PRRIP – ED OFFICE MEMORANDUM

TO: CONTRACTORS
FROM: EXECUTIVE DIRECTOR'S OFFICE
SUBJECT: ELM CREEK COMPLEX RFP – CONTRACTORS' QUESTIONS
DATE: MARCH 14, 2011

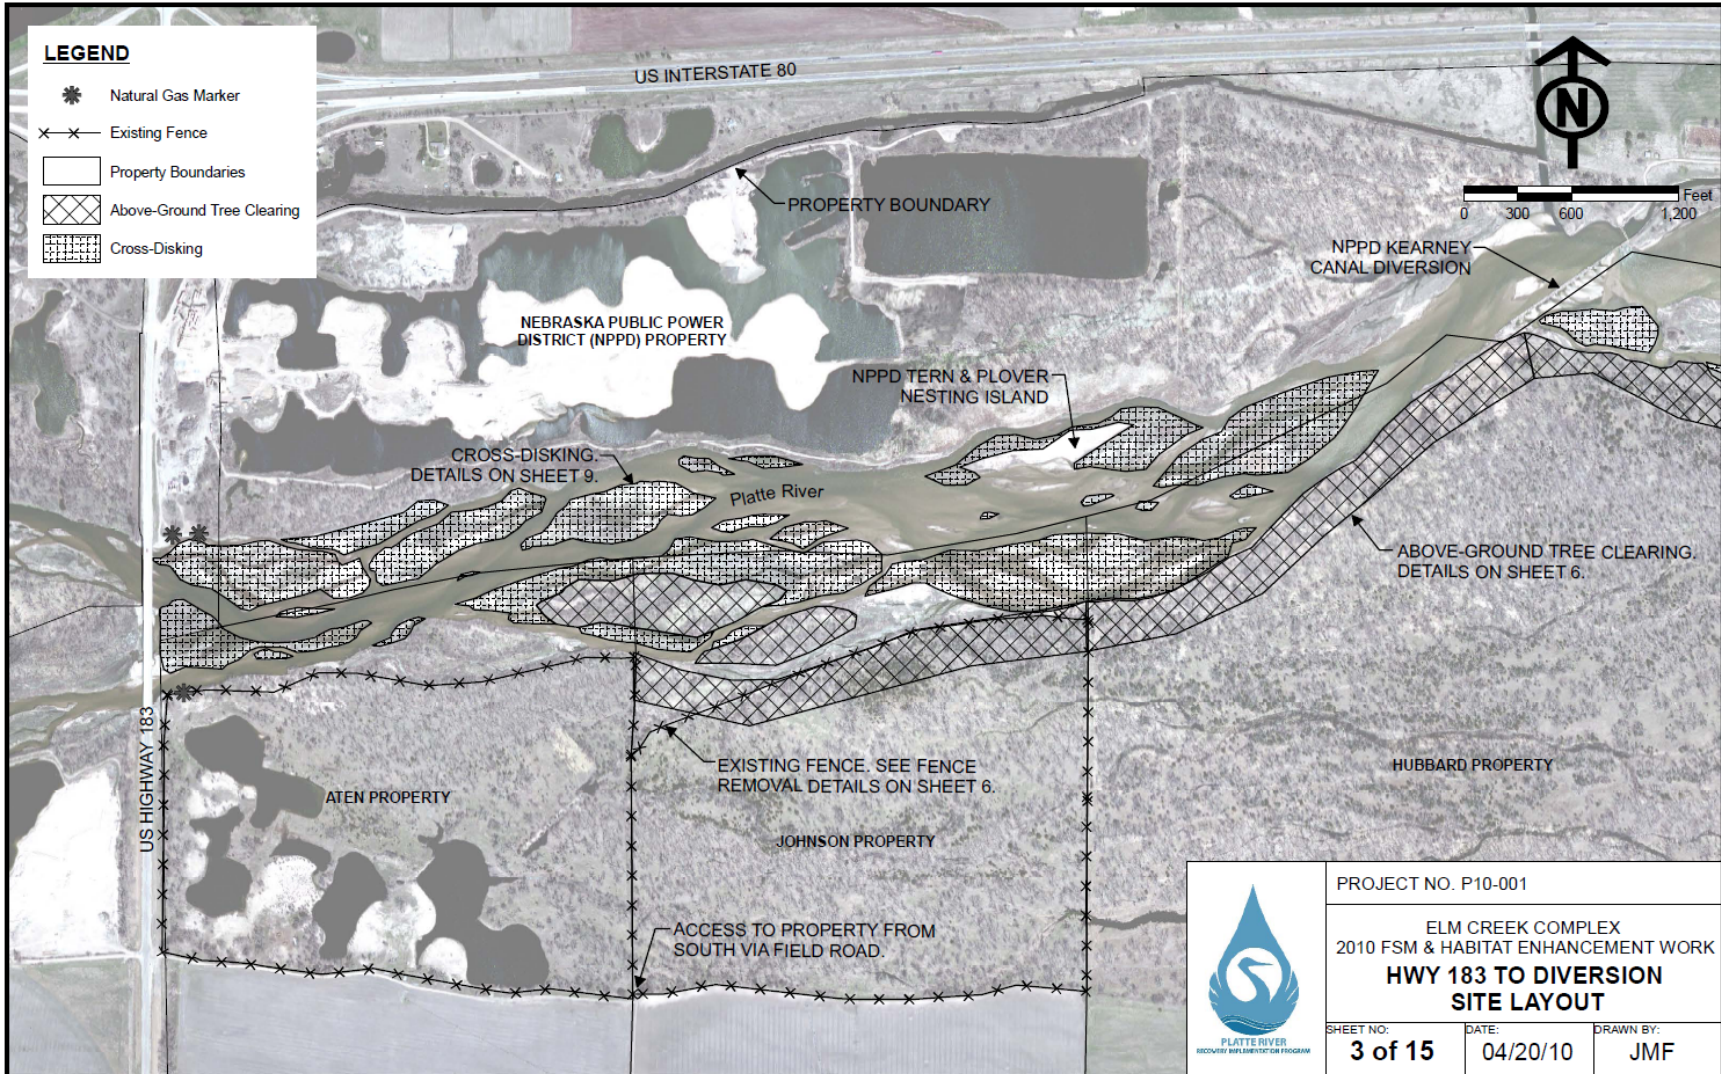
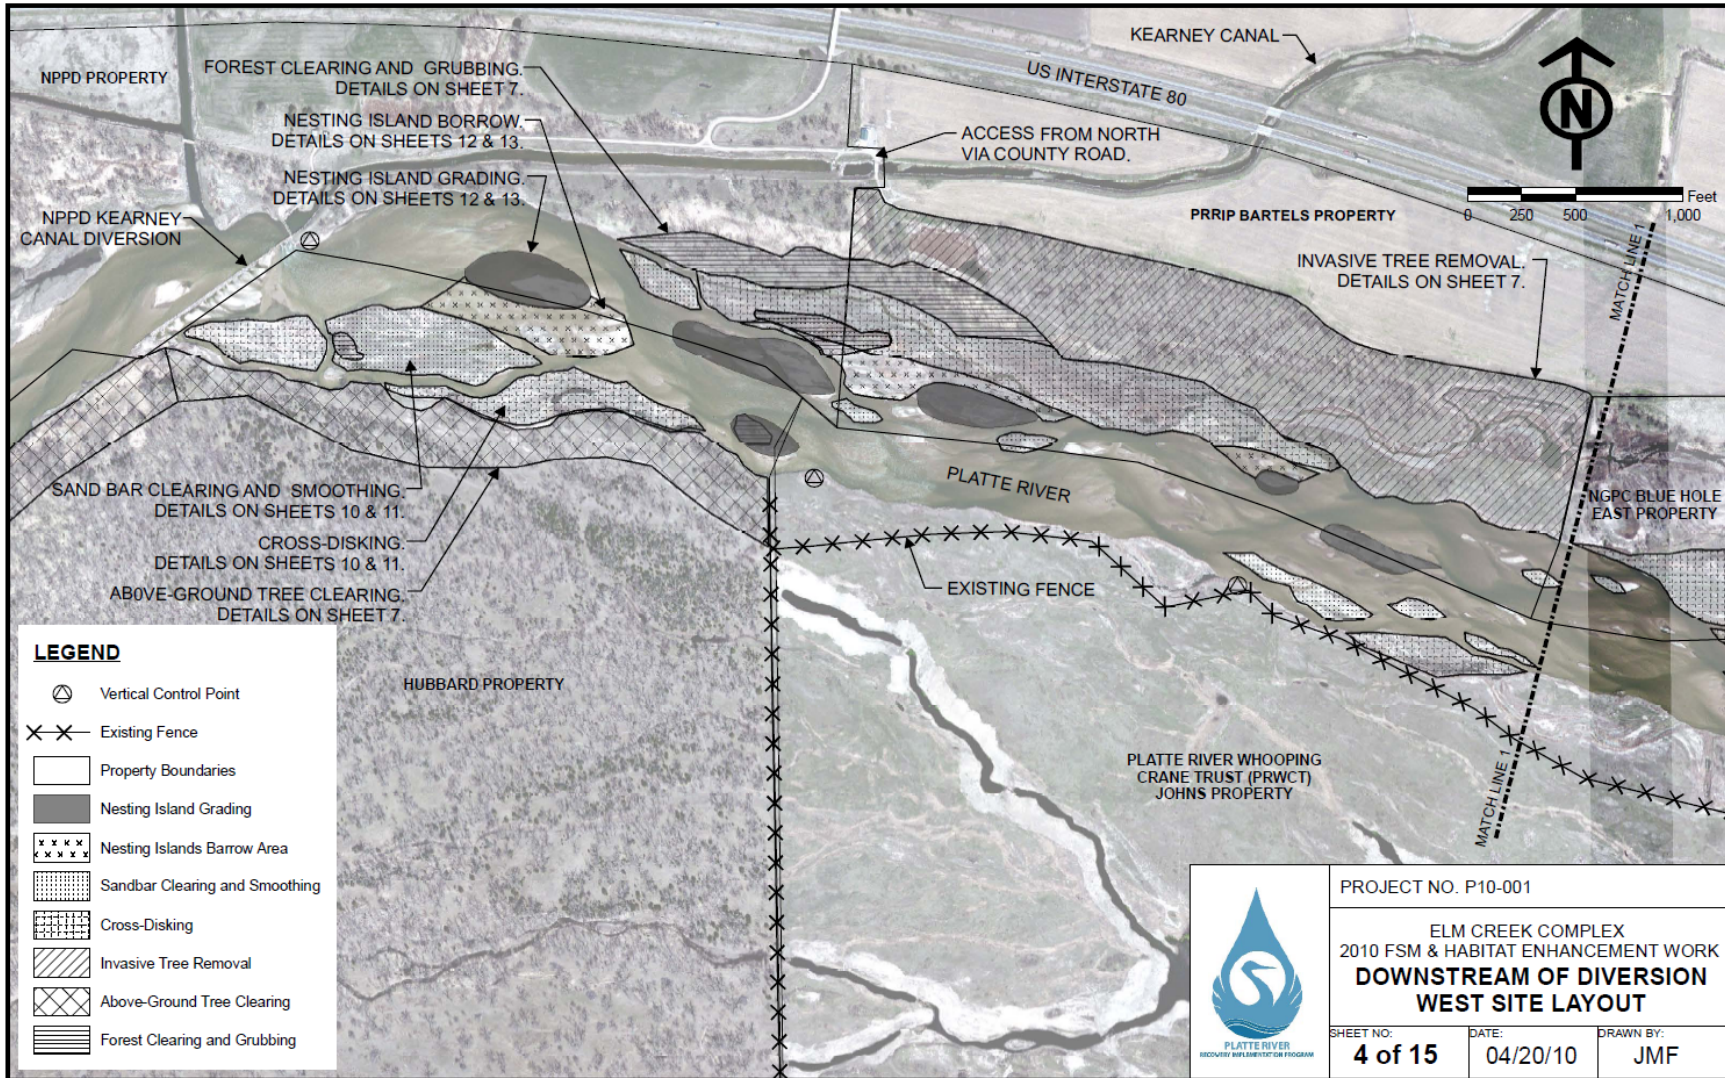
3. Tom Grindeland, West Consultants
 - a. Question: Can you provide any more details on the vegetation removal that occurred last fall? In particular, can you describe the specific location and extent of the vegetation removal that occurred?

- b. EDO Answer: The areas of cross-disking and above-ground tree clearing completed last fall within the Elm Creek Complex are shown in the attached 3 design and construction sheets. These figures are accurate to within about 95% of what was actually completed.
